# REPORT OF THE SAFOD ENGINEERING SUBCOMMITTEE OF THE ADVISORY COMMITTEE FOR GEOSCIENCES, MARCH 30, 2011

The DIP was installed (Figure 4) in September 2008 at the conclusion of the MREFC project. The DIP used what was considered the best design and equipment that fit within a budget that was much smaller than originally planned. An original budget of \$2.56M had been reduced to less than \$0.4M due to overruns in the core recovery portion of the program. Moreover, NSF informed SAFOD that no additional funds would be made available under MREFC. As such, considerable sacrifice had to be made to the original design, including eliminating portions of the instrumentation – most notably the pore pressure sensor and the preferred use of HT electronics that had been recommended by Sandia for longevity. Unfortunately, within two weeks of deployment, all elements of the DIP ceased functioning. In response, the SAFOD Engineering Subcommittee (henceforth referred to as “the committee”) of the Advisory Committee for Geosciences was established in August 2010 and charged with:

Figure 3 SAFOD DIP Showing the Two Separate Control Lines

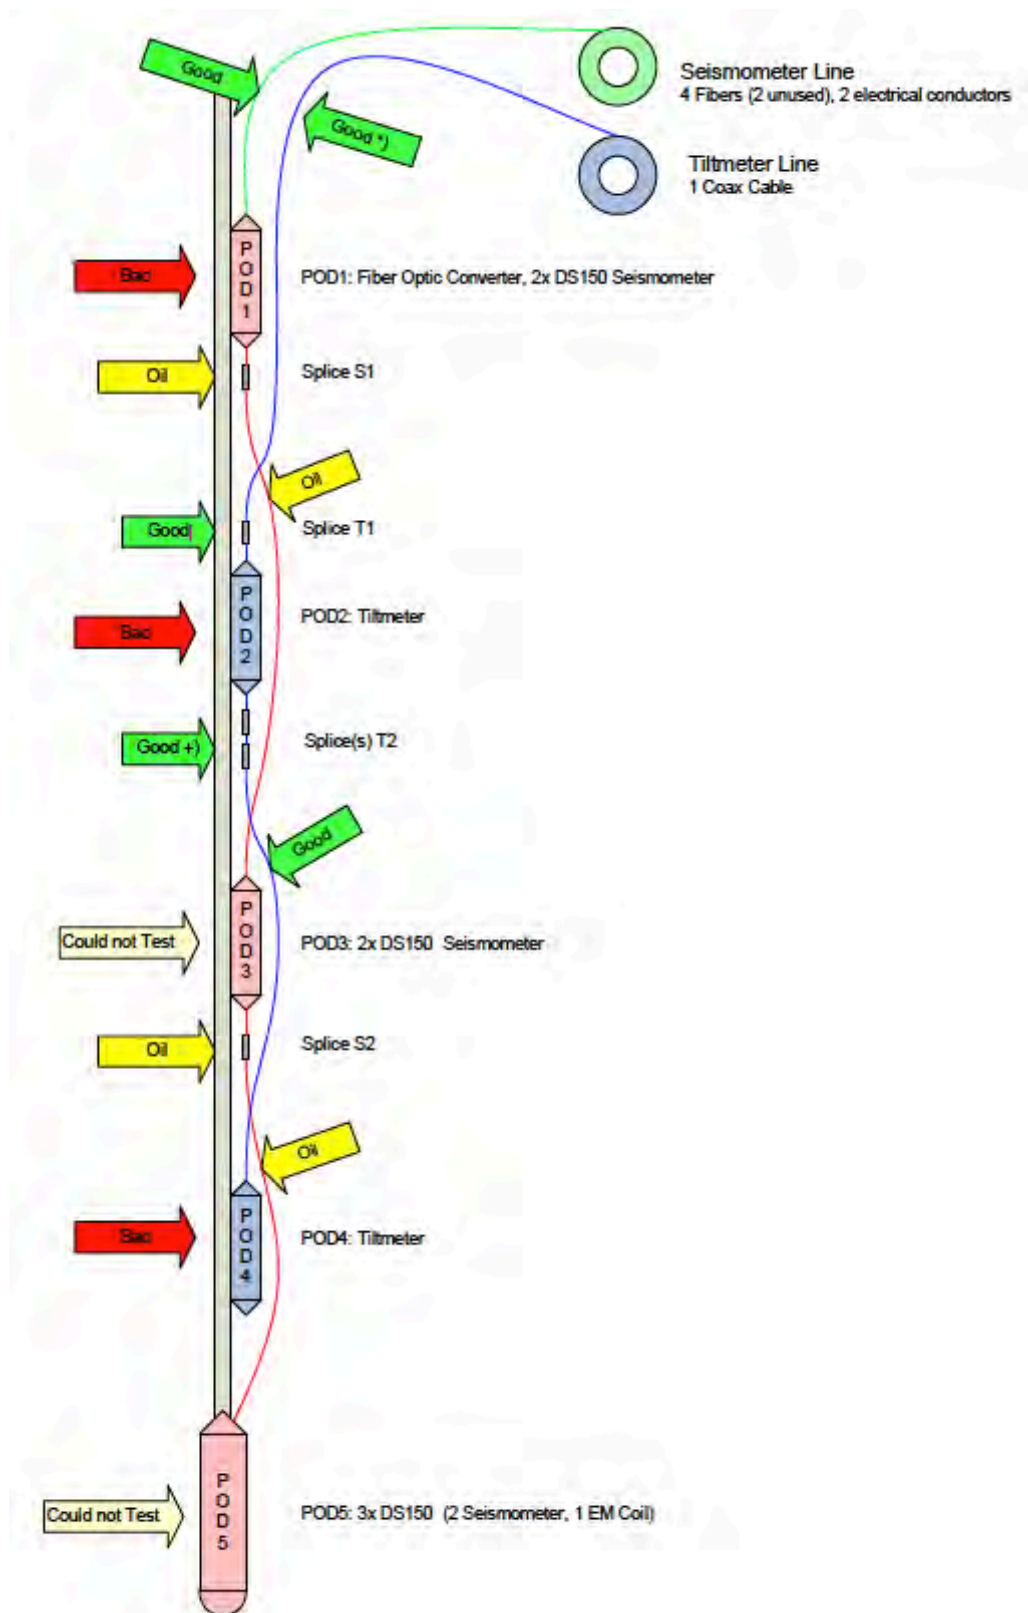
Because the entire DIP is approximately 300 feet long to accommodate vertical spacing between seismometers and tiltmeters, it was necessary to connect the Pods together in the field via splices between them (see Figure 3). The splicing was performed on the floor of the drill rig during DIP installation. Splices consisted of soldered connections of stripped ends with no additional strain relief, such as by twisting conductors together (Figure 8). The splices were housed in short sections of 3/8" tubes with Swagelok fittings at both ends (Figure 9). The committee felt that having splices was a design flaw, since the failure of a single splice could, under certain conditions, take out several all instruments in a string. An alternative would be to consider each Pod as an independent instrument, although arguably more costly.

- A broken wire was found in Splice S2 (see Figure 3). It is not clear if the break occurred before or during disassembly.

**Figure 6 Spikes Developing in Seismic Data**

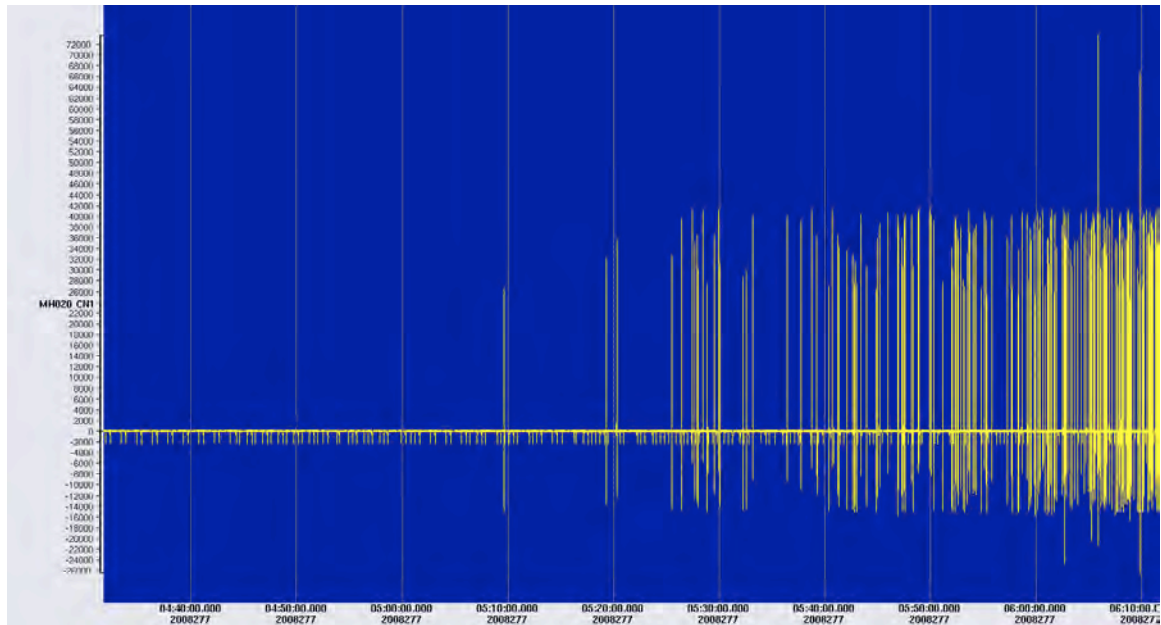
4. Communication problems developed shortly thereafter.
5. Approximately 10 days after deployment, all communication was lost with the exception of the instrument in Pod 1. Several days later the last instrument went into a spasm of dropouts, spikes (Figure 6) and reboots. Dropouts can be indicative of cable issues due to leakage or to premature electronic component failure.

Figure 8 Poorly Soldered Splices

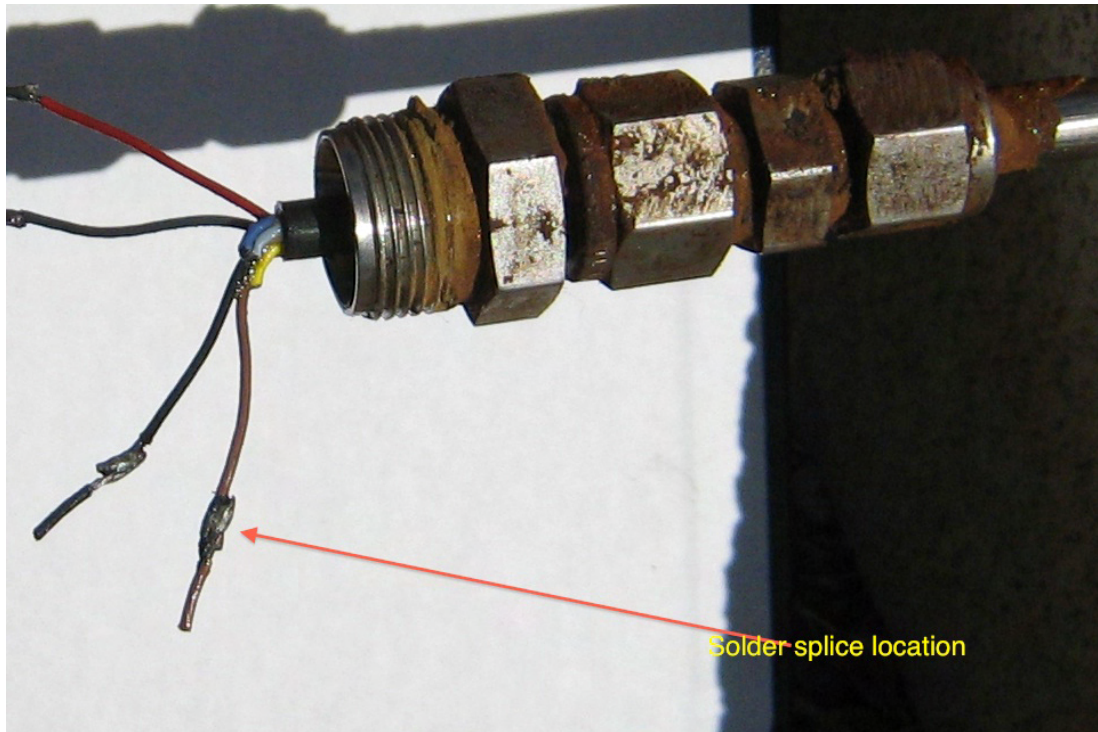
- The Mobil 1 had migrated between Pods through the ¼ inch tubing, indicating that the cable heads were probably compromised in some cases.
- Electrical splices between Pods were poorly done. The exposed ends of the wires were placed parallel to one another and soldered with no mechanical connection (Figure 8). Individual splices within their protective steel tubes were not staggered. A broken brown wire was found to have occurred near splice S2 between Pods 3 and 5. Insulation materials around the soldered connections had badly deteriorated in many cases. This may have allowed conductive fluid that migrated along the ¼ inch tubing and into the splices to create short-circuits between individual splices.

Figure 10A Pod Cap and Top of Cable Head.

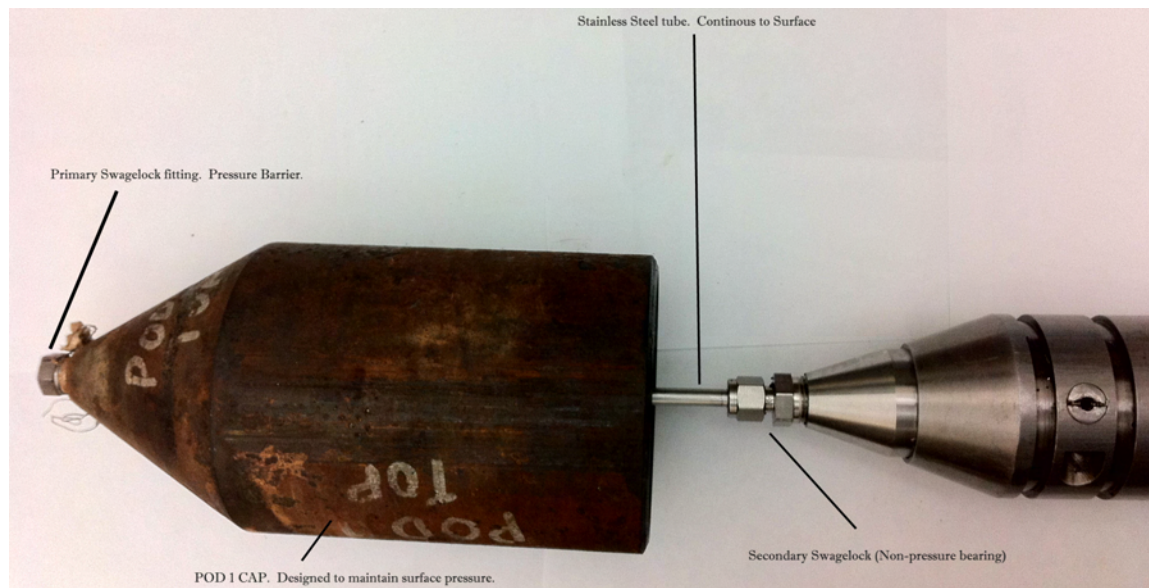
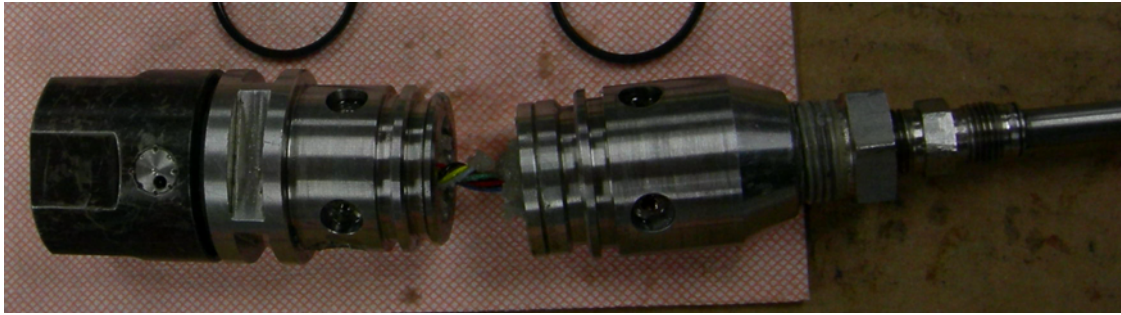
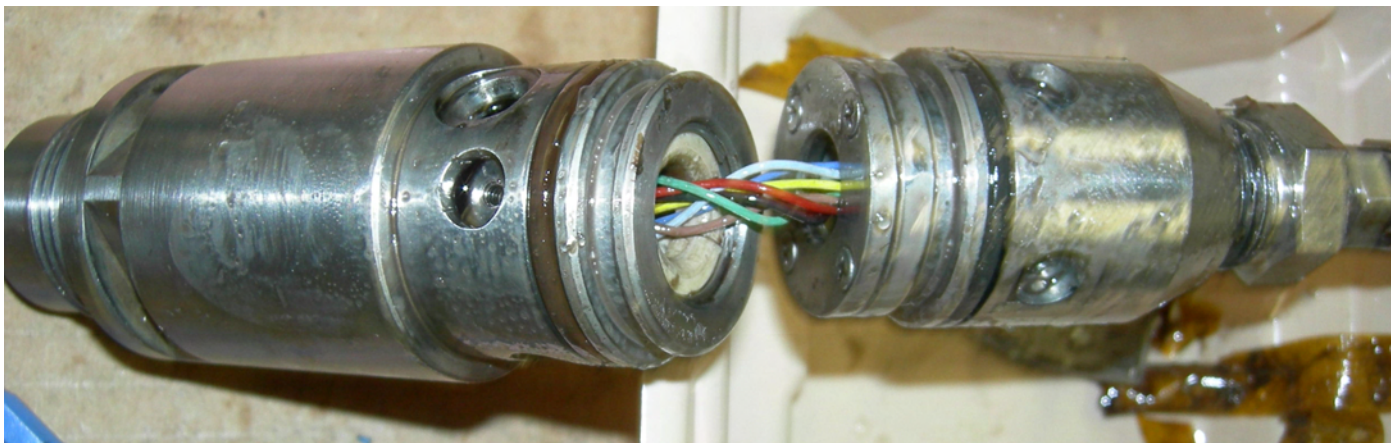
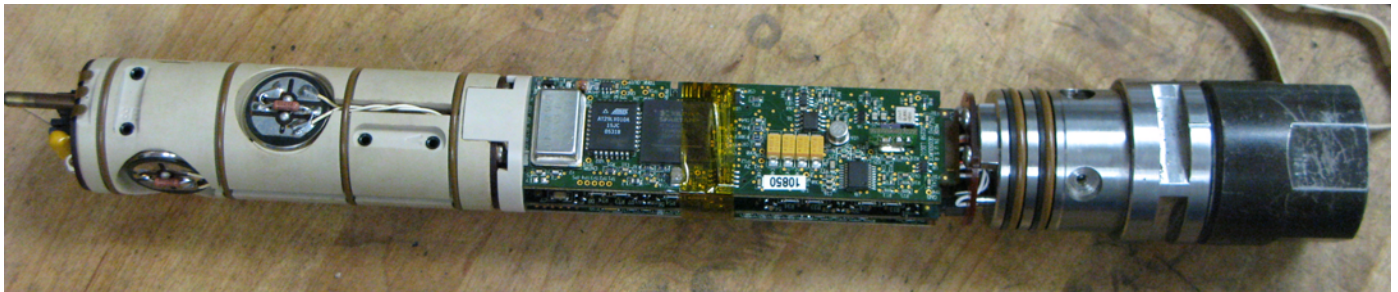
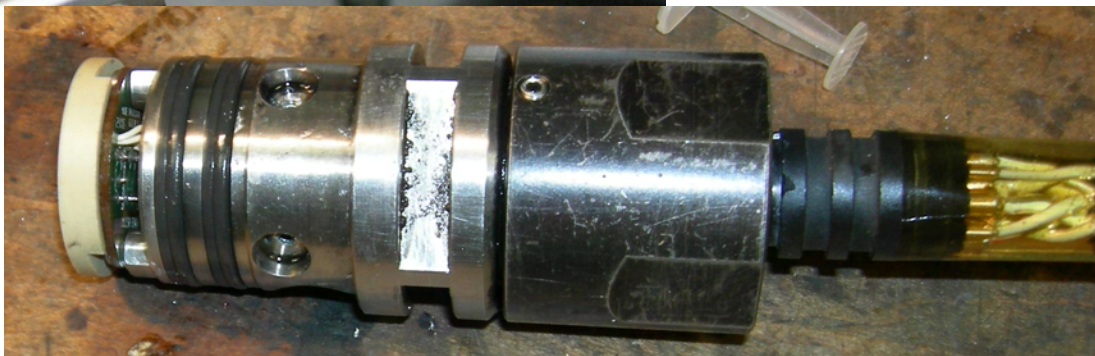
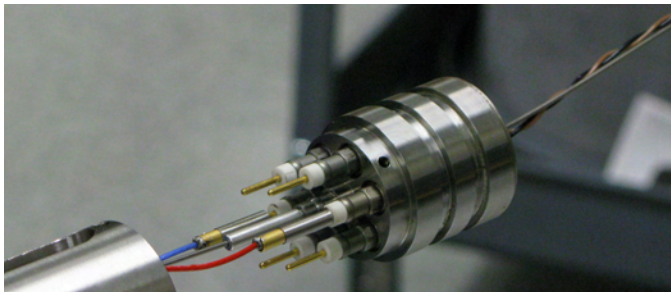
- ❖ The committee recommends that further study be performed on the actual O-rings and feeds-thru (Figure 10) used in the DIP to determine if they maintained integrity (blocking fluid, gas, and volatiles) during the two years the DIP was in the SAFOD borehole. It would also be useful to perform various stress tests on Swagelok fittings to determine if they can hold up under the rigors of installation, as well as for long periods under corrosive fluid and gas conditions.
